## **AMENDMENTS TO THE DRAWINGS**

### **REMARKS**

This amendment is in response to the office action dated March 18, 2005. In the office action, the drawings were objected to, and claims 1-15 were rejected. A detailed discussion of each item in the office action follows.

Replacement Sheet - Application Serial Number 10/708,484

Figure 1

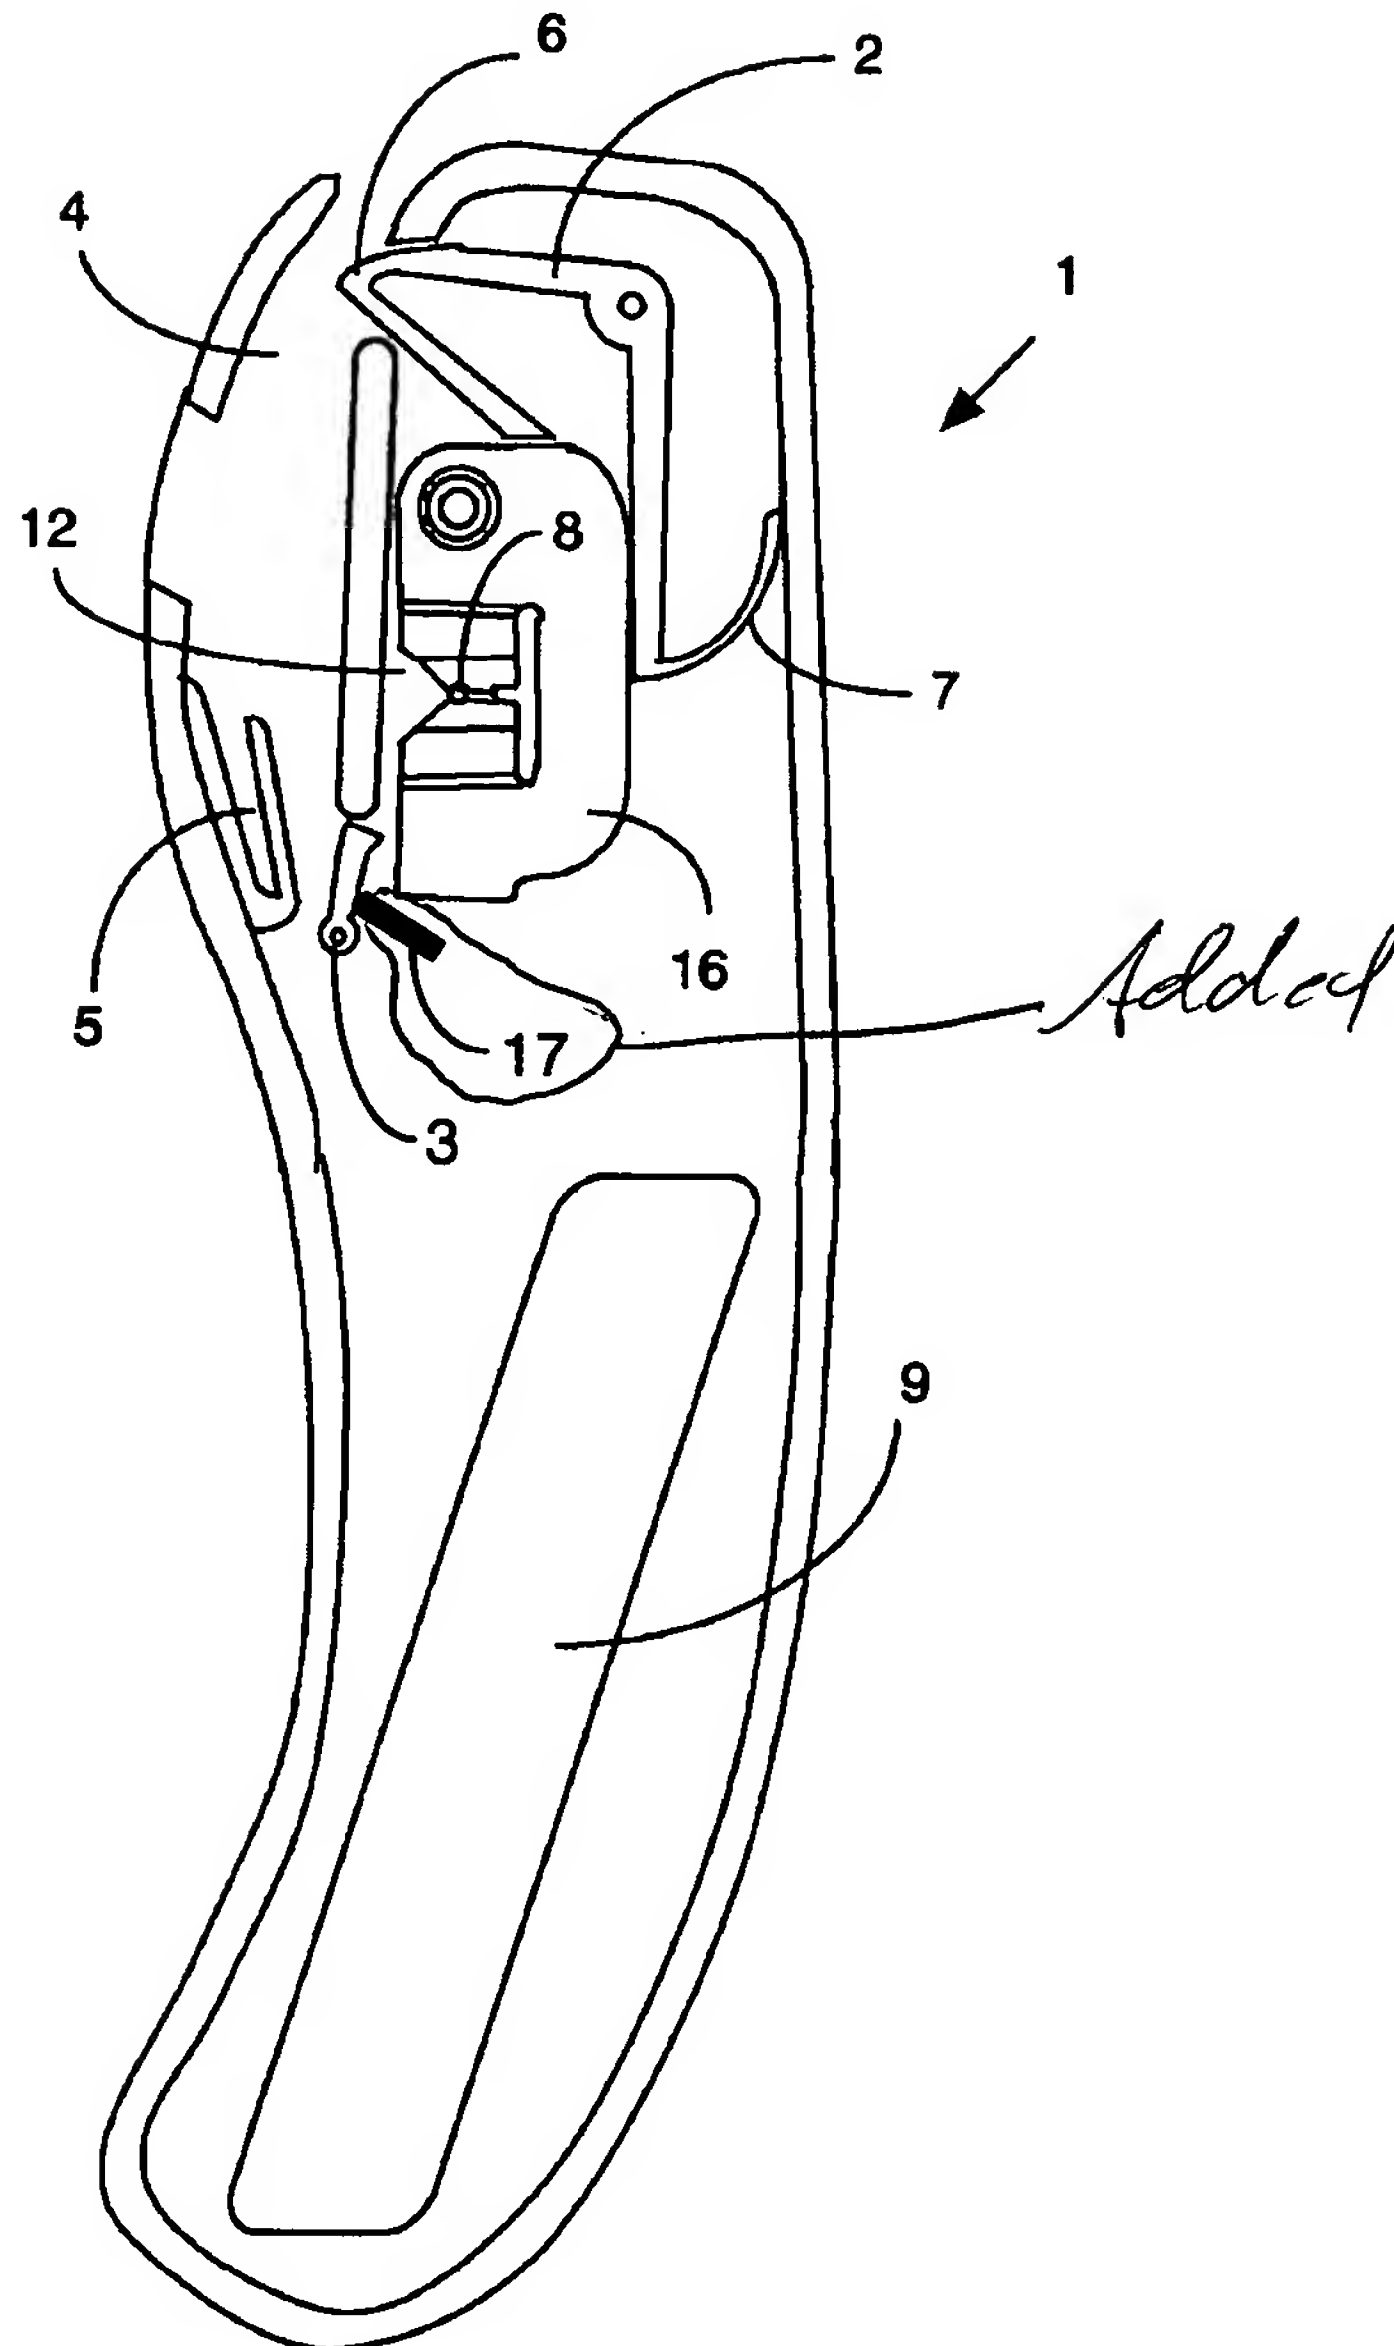
Five sheets of replacement drawings for figures 1-4 are attached. In addition, five sheets of drawings are attached for the Examiner's convenience. Figures 1-4 have been amended to illustrate the door spring 17 as set forth in original claims 3, 8-9 and 13-14.

In item 1 of the office action, the drawings were objected to. Drawings 1-4 have been amended to show spring 17 as required by the Examiner.
